**Sub:- Construction of quarantine-cum-Transit facility in the National Zoological Park, New Delhi – Regarding.**

The design submitted for proposed construction of quarantine – cum transit facility in the National Zoological Park, New Delhi was placed before the 2<sup>nd</sup> Meeting of the Expert Group on Zoo Designing of Central Zoo Authority held on 13<sup>th</sup> February, 2008.

PROPOSED QUARANTINE HOUSE  
 AT  
 NATIONAL ZOOLOGICAL PARK  
 NEW DELHI

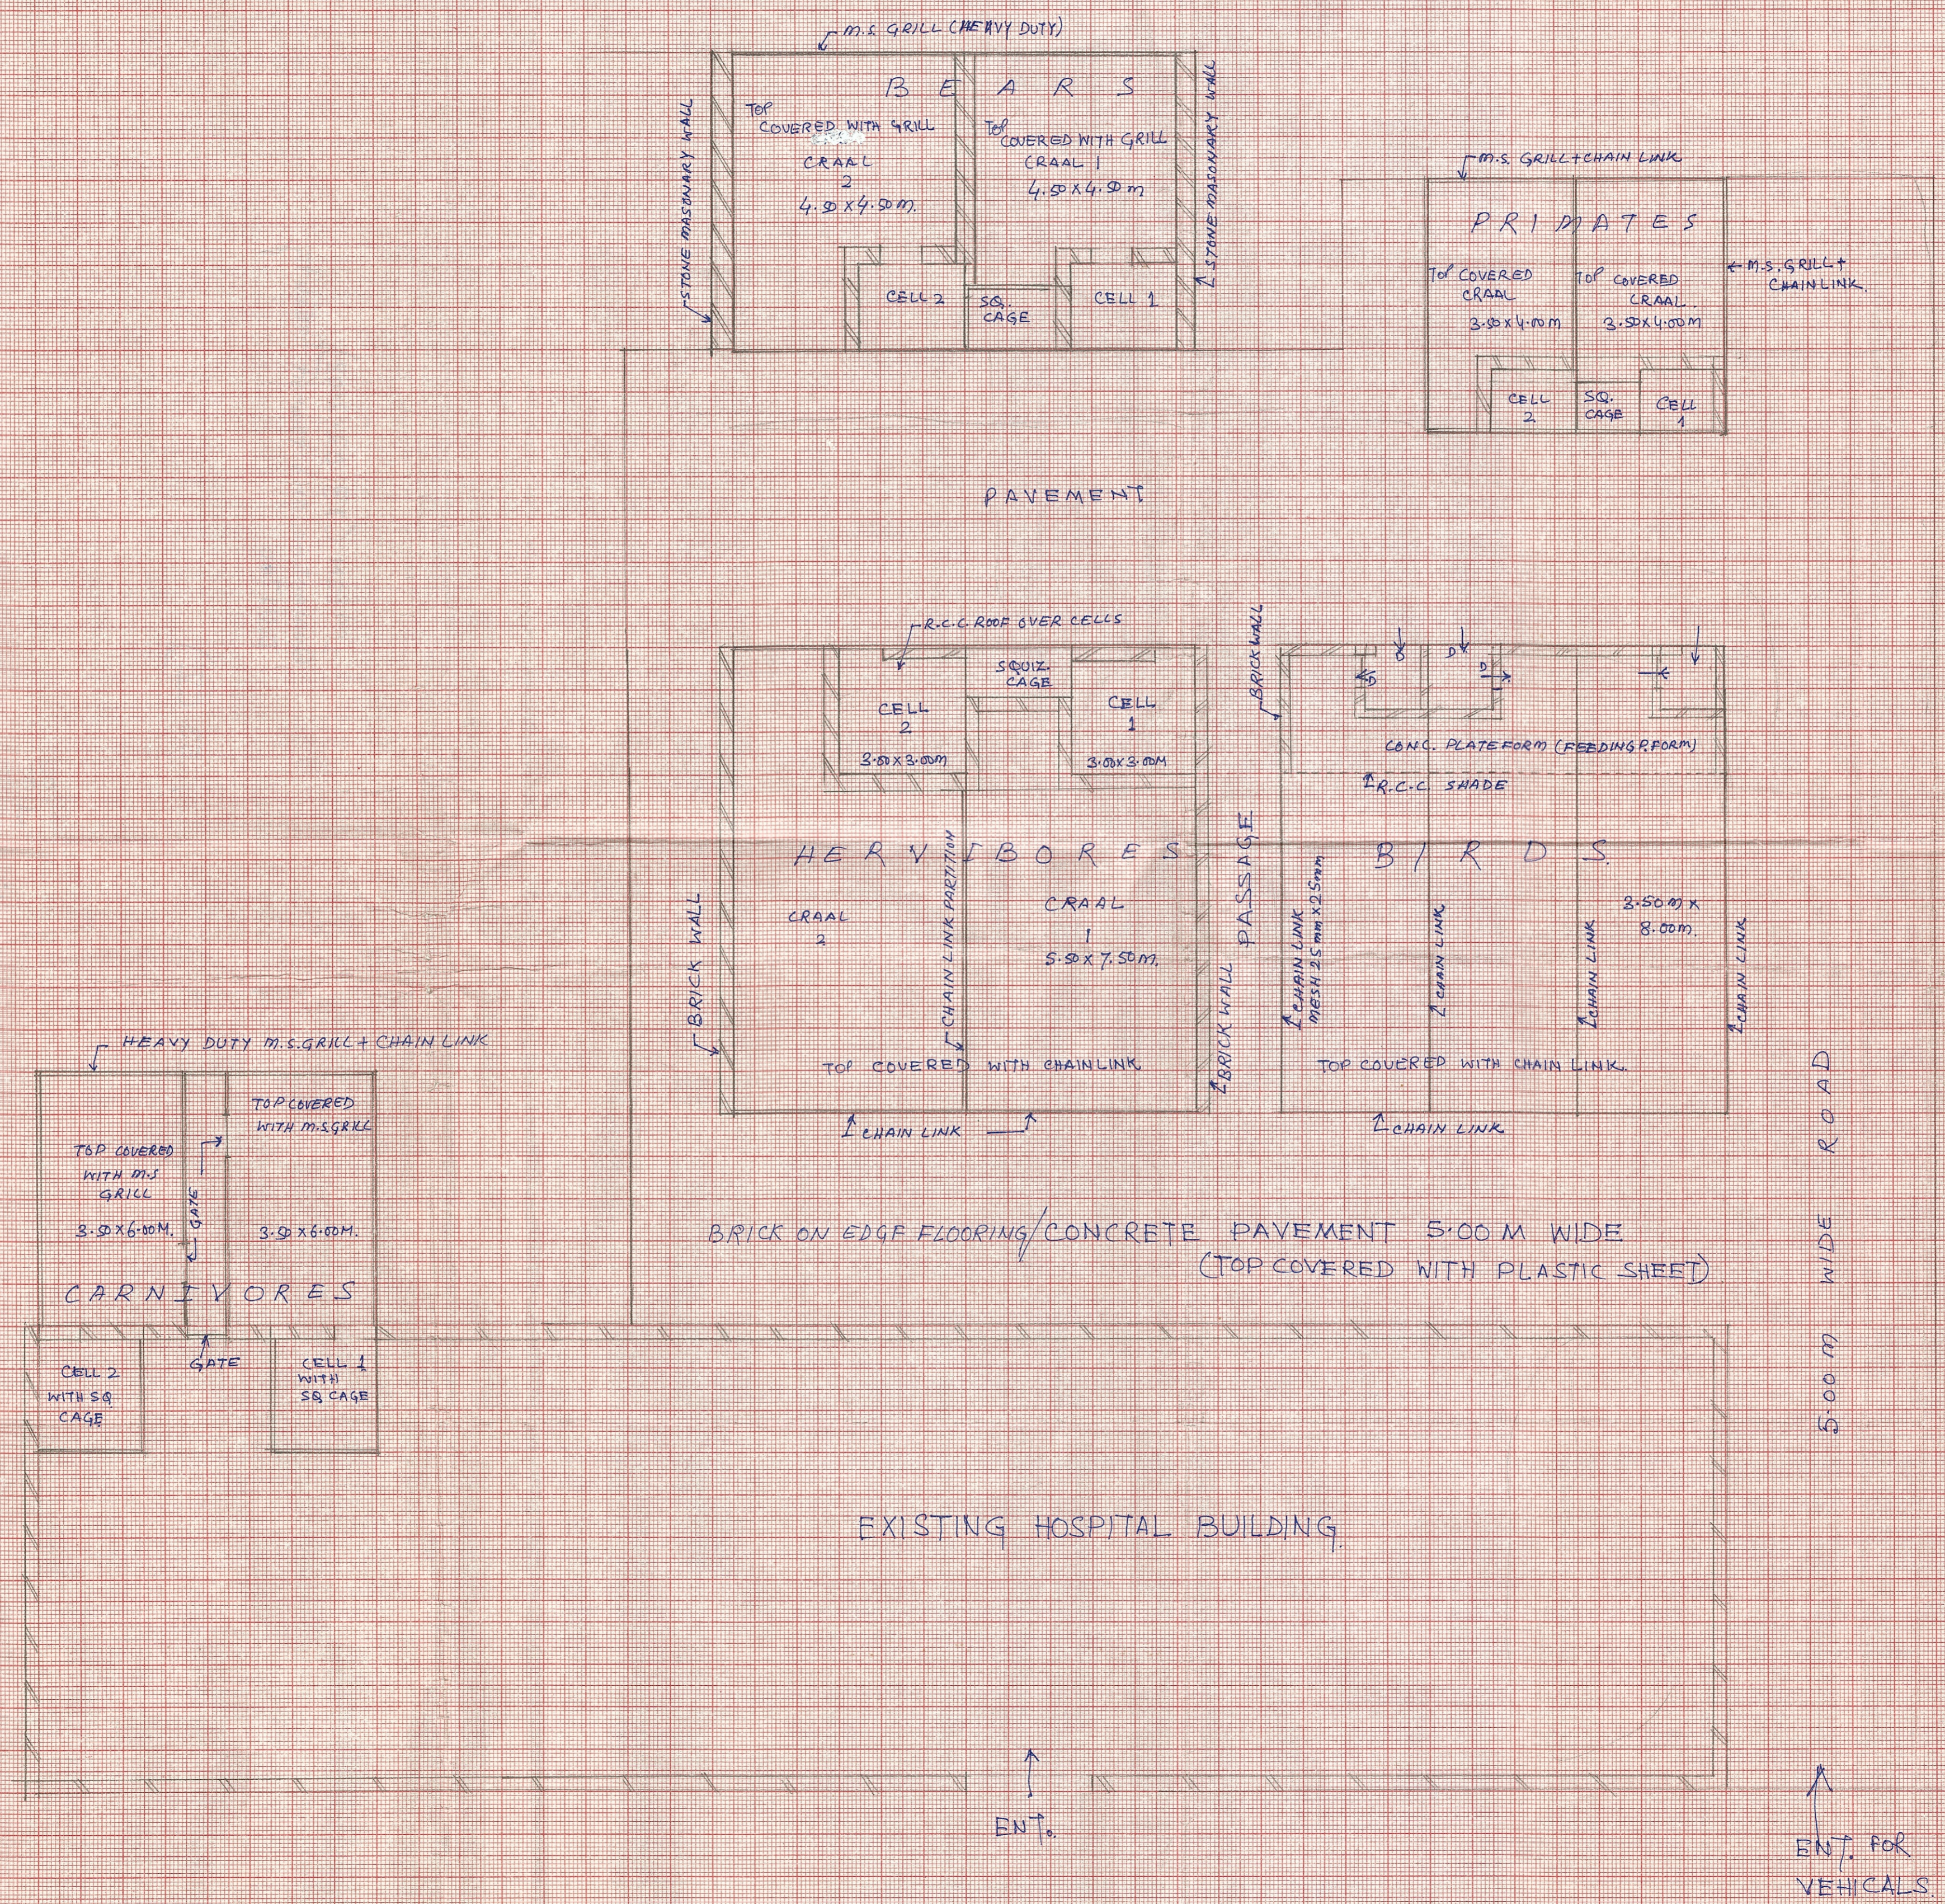
- The provision for quarantine of reptiles (snakes) should also be provided.
- It should be ensured that the vehicles have an easy access upto Bear and Monkey enclosure. It should also be ensured that the required adequate turning radius provided for the vehicles.
- The structure of each enclosure should be adequate as per the species requirement since the details are not submitted with the present proposal.
